Product Change Notification - RMES-18SSPJ335

CCB 3862 Final Notice: Implement Microchip top marking changes for selected Microsemi CBU products.

PART MARKING GUIDELINE (Supplement to PCN# RMES-18SSPJ335)

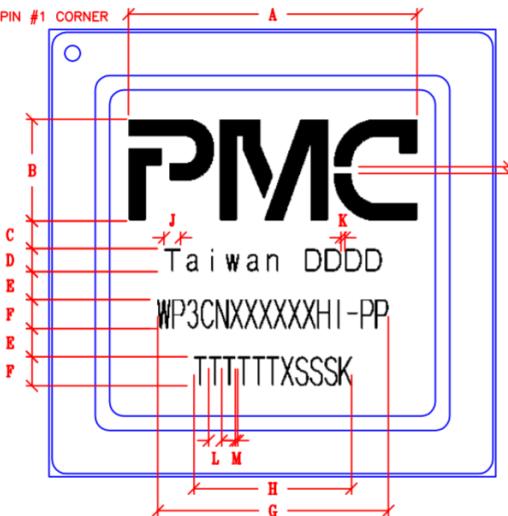
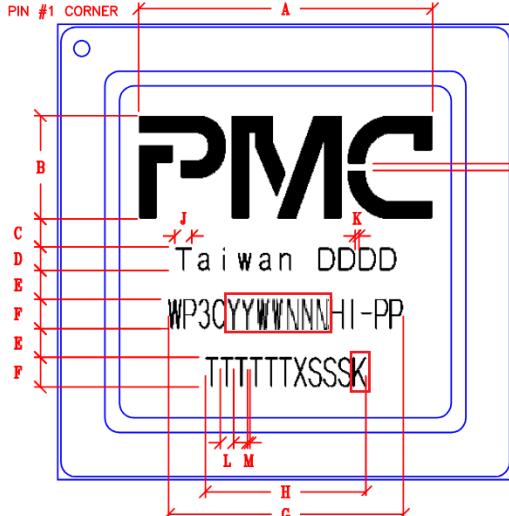
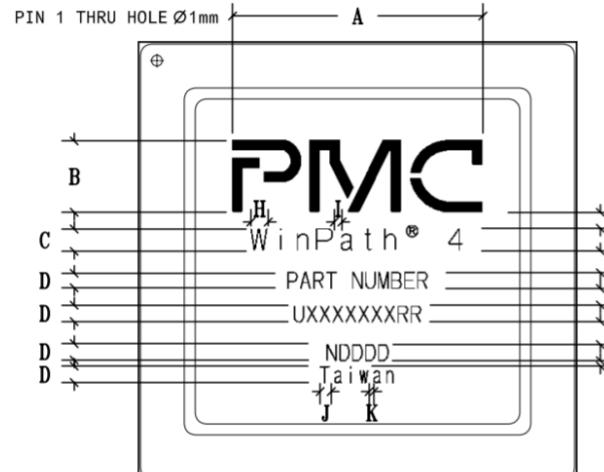
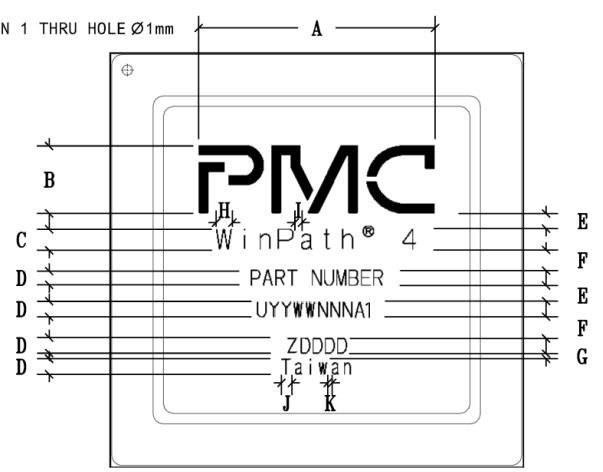
Product Family Name	 Pre-Change Marking Diagram (MSCC) Microsemi	 Post-Change Marking Diagram (MCHP) Microchip
Product Family Name	Pre-Change Marking Guidelines (MSCC) Microsemi	Post-Change Marking Guidelines (MCHP) Microchip
WinPath 2 (WP2)	 <p>Top Mark</p> <p>Line 1 – PMC Logo</p> <p>Line 2 – Product Family Name</p> <p>Line 3 – Catalog Part Number</p> <p>Line 4 – XNXXXXXXX = MSCC Lot #</p> <p>Bottom left corner = Assembly Code</p> <p>Bottom right corner = Country of Origin and duplicated assembly date code</p> <p>● = Pin 1 location</p>	 <p>Top Mark</p> <p>Line 1 – PMC Logo</p> <p>Line 2 – Product Family Name</p> <p>Line 3 - Catalog Part Number</p> <p>Line 4 – XNYYWWNNNN = MCHP Trace code</p> <p>Bottom left corner = Hard coded random characters</p> <p>Bottom right corner = Country of Origin and assembly date code</p> <p>● = Pin 1 location</p>
WinPath 2L (WP2L)	 <p>Top Mark</p> <p>Line 1 – PMC Logo</p> <p>Line 2 – Catalog Part Number</p> <p>Line 3 – Speed, Revision and Assembler code</p> <p>Line 4 – YYYYYYYY – Lot code and Country of Origin</p> <p>● = Pin 1 location</p>	 <p>Top Mark</p> <p>Line 1 – PMC Logo</p> <p>Line 2 - Catalog Part Number</p> <p>Line 3 – Speed, Revision and Assembler code</p> <p>Line 4 – YYWWNNNN = MCHP Trace code and Country of Origin</p> <p>● = Pin 1 location</p>

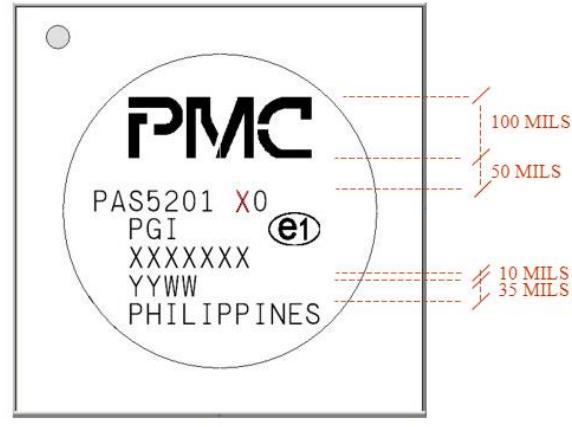
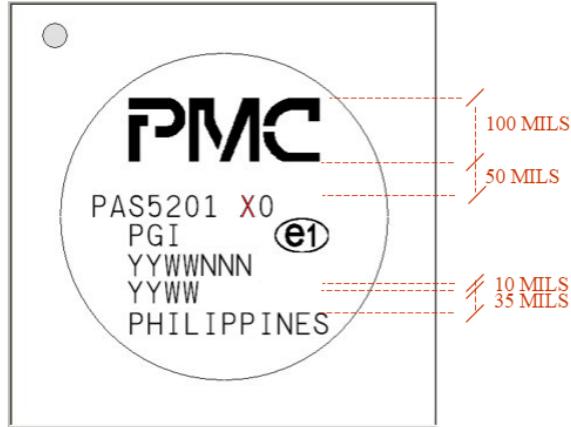
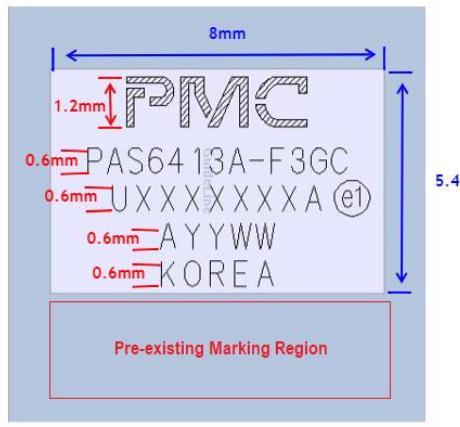
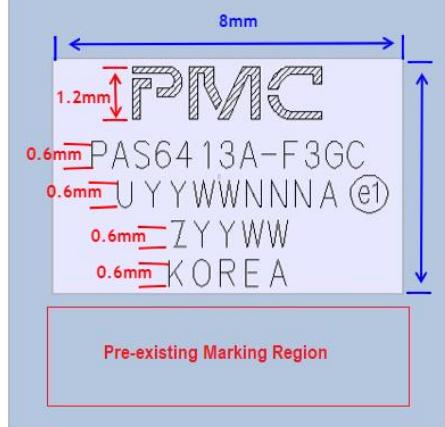
Product Family Name	Pre-Change Marking Diagram (MSCC) Microsemi	Pre-Change Marking Guidelines (MSCC) Microsemi	Post-Change Marking Diagram (MCHP) Microchip	Post-Change Marking Guidelines (MCHP) Microchip
WinPath 3 & WinPath 3SL (WP3 & WP3SL)	 <p>Top Mark</p> <p>Line 1 – PMC Logo</p> <p>Line 2 – Country of Origin and Assembler date code</p> <p>Line 3 -</p> <p>WP3CNXXXXXXHI -PP = Assembler code and MSCC Lot #</p> <p>Line 4-</p> <p>TTTTTTXSSSK = Assembly Lot Number</p> <p>● = Pin 1 location</p>	 <p>Top Mark</p> <p>Line 1 – PMC Logo</p> <p>Line 2 – Country of Origin and Assembler date code</p> <p>Line 3 -</p> <p>WP3CYYWWNNNHI -PP =</p> <p>WP3C = Catalog Part Numbers YYWWNNN = MCHP Trace code HI -PP = Catalog Part Numbers</p> <p>Line 4</p> <p>TTTTTTXSSSK = Assembly Lot Number</p> <p>● = Pin 1 location</p>		
WinPath 4 (WP4)	 <p>Top Mark</p> <p>Line 1 – PMC Logo</p> <p>Line 2 – Product Family Name</p> <p>Line 3 – Part Number</p> <p>Line 4 -</p> <p>UXXXXXXXRR = Fab Code, MSCC Lot #, and Revision code</p> <p>Line 5 -</p> <p>NDDDD = Assembler code and date code</p> <p>● = Pin 1 location</p>	 <p>Top Mark</p> <p>Line 1 – PMC Logo</p> <p>Line 2 – Product Family Name</p> <p>Line 3 – Part Number</p> <p>Line 4 -</p> <p>UYYWWNNNA1 =</p> <p>U – Hard coded random characters YYWWNNN – MCHP Trace code A1 – Hard coded random characters</p> <p>Line 5</p> <p>ZDDDD =</p> <p>Z – Hard coded random characters DDDD - Assembler code and date code</p> <p>● = Pin 1 location</p>

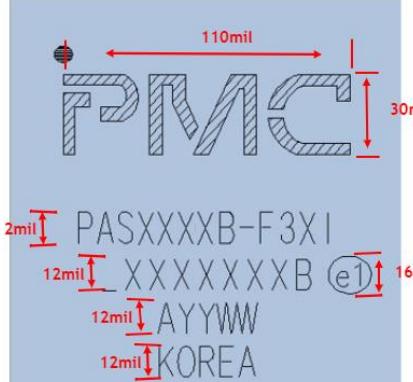
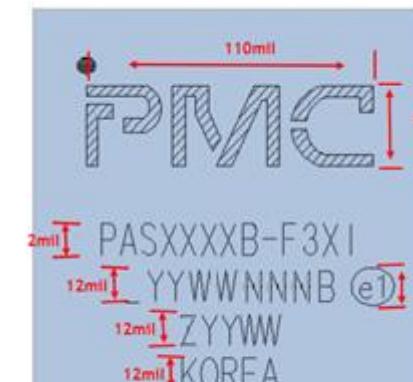
Product Family Name	Pre-Change Marking Diagram (MSCC) Microsemi	Pre-Change Marking Guidelines (MSCC) Microsemi	Post-Change Marking Diagram (MCHP) Microchip	Post-Change Marking Guidelines (MCHP) Microchip
PAS5201 (PAS5201A0 and PAS5201L0)		<p>Top Mark</p> <p>Line 1 – PMC Logo</p> <p>Line 2 & Line 3 – Catalog Part Number</p> <p>Line 4- XXXXXX = Lot code marking</p> <p>Line 5 – YYWW = Assembler date code</p> <p>Line 6 – Country of Origin</p> <p>● = Pin 1 location</p>		<p>Top Mark</p> <p>Line 1 – PMC Logo</p> <p>Line 2 & Line 3 – Catalog Part Number</p> <p>Line 4- YYWWNNNN = MCHP trace code</p> <p>Line 5 – YYWW = Assembler date code</p> <p>Line 6 – Country of Origin</p> <p>● = Pin 1 location</p>
PAS6x13 (PAS6413 and PAS6513)		<p>Top Mark</p> <p>Line 1 – PMC Logo</p> <p>Line 2 – Catalog Part Number</p> <p>Line 3 - UXXXXXXA = Lot code marking</p> <p>Line 4 – AYYWW = Assembler date code</p> <p>Line 5 – Country of Origin</p>		<p>Top Mark</p> <p>Line 1 – PMC Logo</p> <p>Line 2 – Catalog Part Number</p> <p>Line 3 - U = Hard coded random characters YYWWNNNN = MCHP trace code A = Hard coded random characters</p> <p>Line 4 – Z = Hard coded random characters YYWW = Assembler date code</p> <p>Line 5 – Country of Origin</p>
